U.S. NUCLEAR REGULATORY COMMISSION
REGION I

Report No. 50-286/89-09

Facility Name: Indian Point Nuclear Generating Station, Unit 3

Inspection Summary: Routine unannounced inspection on April 3-7 and April 18-21, 1989 (Report No. 50-286/89-08)

Figure 1 - Shows cross sectional of transverse macrosection cut from JAP-3 simulated nozzle-elbow mockup. Arrow depicts lack of fusion defect along fusion line between weld and flux core buttered layer.

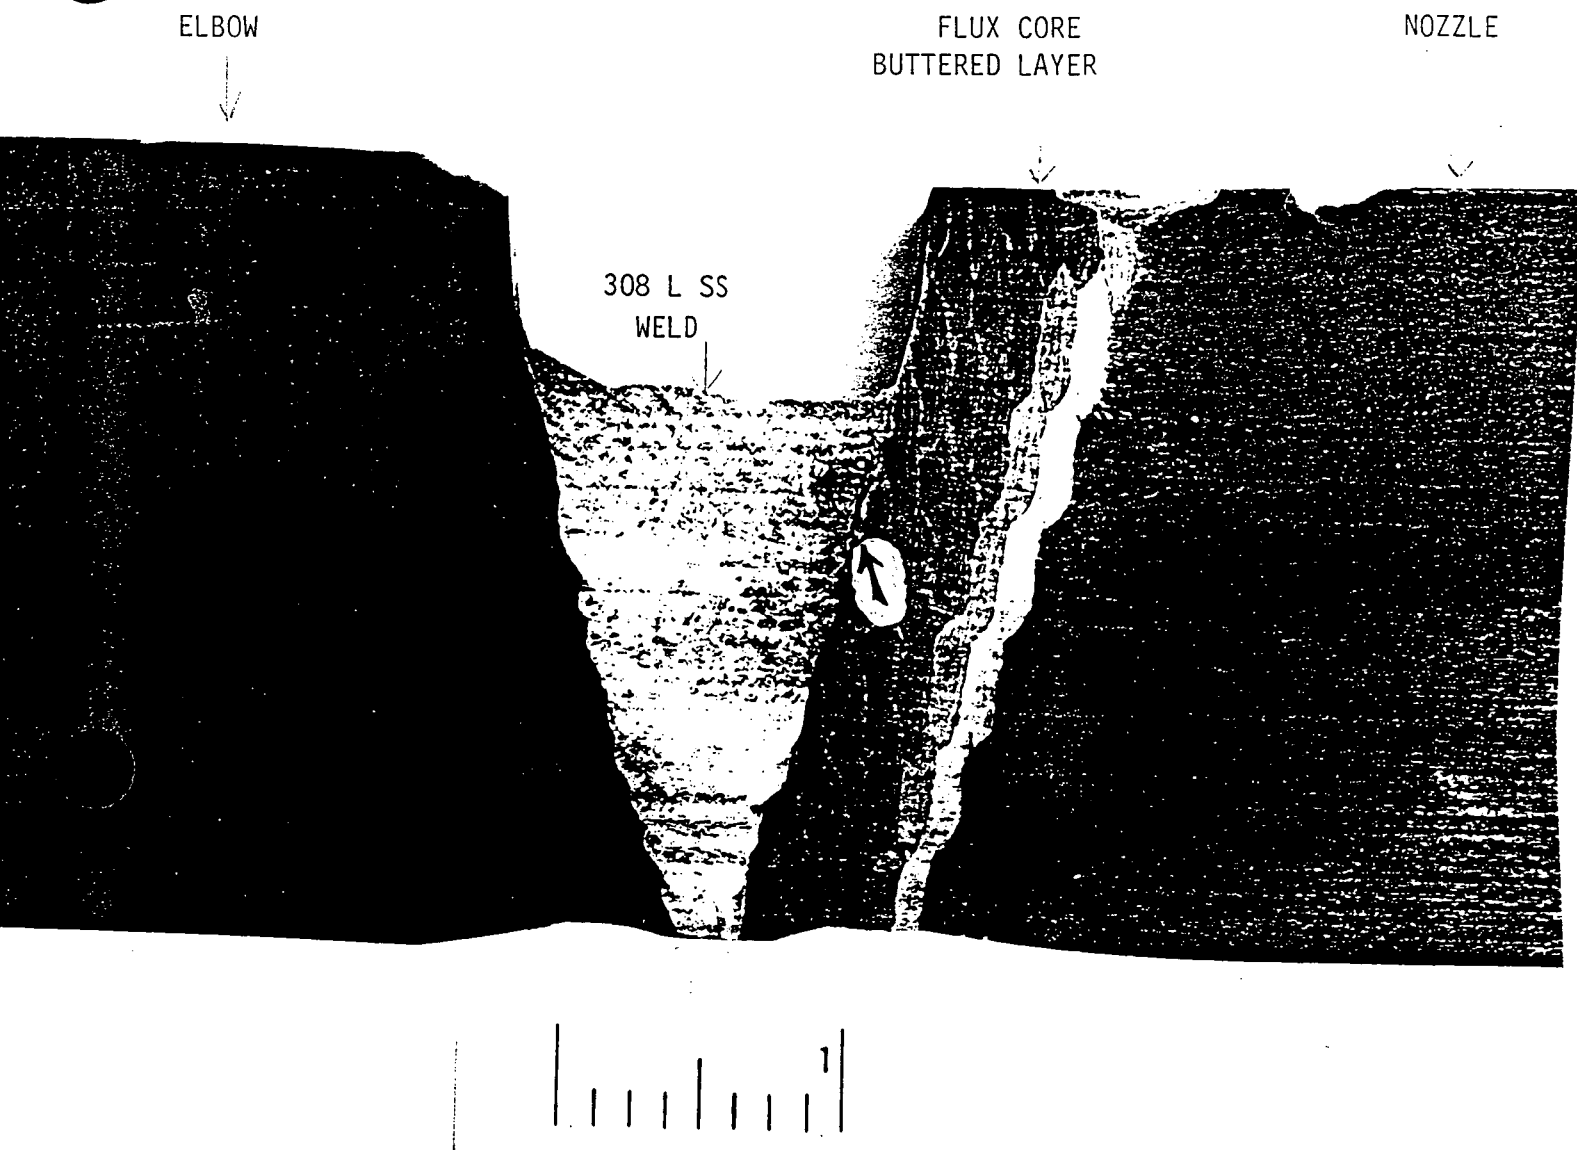
On April 3, 1989 the inspectors met with the licensee's principal engineering and welding personnel and were informed that the licensee was not able to consistently produce sound welds in the JAP mockups even though welding was performed under tight supervision by PCI (Power Cutting Incorporated), a subcontractor to Bechtel. As experienced with the steam generator replacement at D.C. Cook Unit 2, where identical materials were employed, the licensee experienced difficulties in the flux core stainless buttered nozzle end preps when "tie-ing in" the adjacent weld beads. The replacement SG's at both sites were fabricated by the same manufacturer. The difficulty was found to be due to lack of fusion that occurred in the middle 1/3 of the thickness, above the change in joint bevel. The licensee presented to the inspector a metallurgical report, prepared by Lucius Pitkin Laboratories, showing the lack of fusion in a mockup cut from JAP-3 that was readily found by radiography. Macroscopic and microscopic examination of sections cut from the mockup showed that the lack of fusion occurred at the interface between the TIG deposited type 308L stainless weld metal and the flux core type 308L stainless buttered layer as shown in the photograph in Figure 1. The report also included the results of Energy Dispersive Spectroscopy (EDS) which revealed significant quantities of calcium, silicon, and a lesser amount of aluminum in the defect, all of which were considered

to be impurities (oxides) generally found in weld fluxes. It was concluded that in all likelihood, these impurities in the weld metal contributed to the lack of fusion. As the result of this experience with the JAP mockups and the experience at D.C. Cook the licensee elected to butter ("seal") the as delivered nozzle weld end preps with three layers of "clean" type 308L stainless weld metal using the automatic TIG process prior to making the nozzle to elbow weld. The licensee proceeded to weld JAP 4 mockup utilizing three layers of TIG deposited 308 L. Radiography and metallographic sectioning, as shown in Figure 2, revealed a sound joint free of defects. (See Figure 2). In addition, the safe end weld joint bevel was modified from 30°, 15°, and 5° to 30° and 19°. The inspector reviewed the documentation covering the TIG buttering operation and found no reported problems except as discussed in Allegation No. RI-89-A-0031 page 6.

The inspector reviewed a sample of the radiographs of the full size JAP nozzle to pipe joint mockups. In general, the mockups appeared to be free of imperfections except for the lack of fusion that had been found and investigated in JAP-3 which was quite obvious. None of the mockups had been examined ultrasonically, but the licensee stated that some of the remaining fragments of the mockup would be ultrasonically examined.
